Access Compliance Report

Public Rights-of-Way

Intersection ID: 17400	Main Street: BAINBRIDGE_RD	Cross Street: VISTA_DR	Location: NW
ADA ID: 91B2F292DAA1	Ramp Type: PerpDiag	Initial Pass/Fail: Fail	Overall Compliance: No
		Severity Score: 10

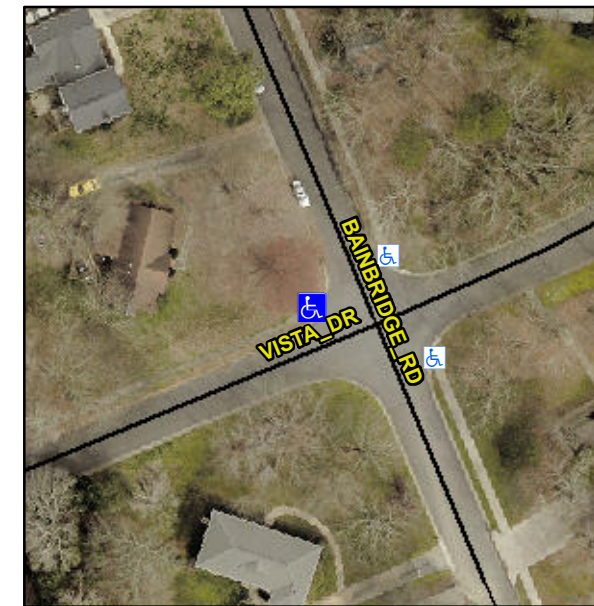
Not Found, R304.5.1, R304.5.3

Compliance	Description	Data	Compliance	Description	Data
N/A	Ramp Length (in)	48.0	Yes	Ramp Slope (%)	7.7
No	Ramp Width (in)	43.0	No	Ramp XSlope (%)	3.0
N/A	Flare Type LT	N/A	N/A	Flare Type RT	N/A
N/A	Flare Slope LT (%)	N/A	N/A	Flare Slope RT (%)	N/A
N/A	Flare Traversable LT?	N/A	N/A	Flare Traversable RT?	N/A
N/A	Landing Length (in)	N/A	N/A	DWS Provided?	N/A
N/A	Landing Width (in)	N/A	N/A	DWS Contrast?	N/A
N/A	Landing Slope (%)	N/A	N/A	DWS Length (in)	N/A
N/A	Landing X Slope (%)	N/A	N/A	DWS Full Width?	N/A
N/A	Landing Curb? (Y/N)	N/A	N/A	DWS Offset (in)	N/A
N/A	Shared Landing?	N/A			
N/A	Gutter Ponding?	N/A	N/A	Gutter Slope (%)	N/A
N/A	Gutter Lip Ht (in)	N/A	N/A	Gutter X Slope (%)	N/A
N/A	Painted X Walk1?	No	N/A	Painted X Walk2?	No
	X Walk 1 Direction	To S		X Walk 2 Direction	To E
N/A	X Walk 1 Width (in)	N/A	N/A	X Walk 2 Width (in)	N/A
	X Walk 1 Slope (%)	0.1		X Walk 2 Slope (%)	4.0
	X Walk 1 X Slope (%)	4.4		X Walk 2 X Slope (%)	0.8

Remove & Replace Curb Ramp With Two New Directional Ramps or Equivalent.
